# Al-Muslim Washing Ltd. & Al-Muslim Garments Accessories Ltd (Extension)

24 March 2024

## 1. Building Information:

**Observation 6:** Construction safety practice (Yarn Dyeing Building).

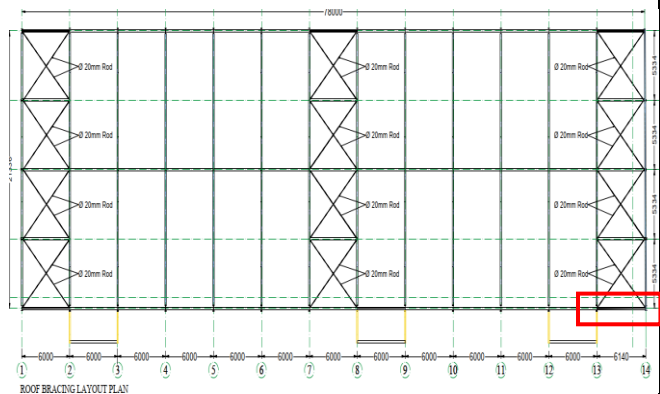
**Description:** Lack of construction safety practice observed on the front part of the building.

The building engineer is required to follow the prescribed construction safety practice as per BNBC Part VII Chapter 3.
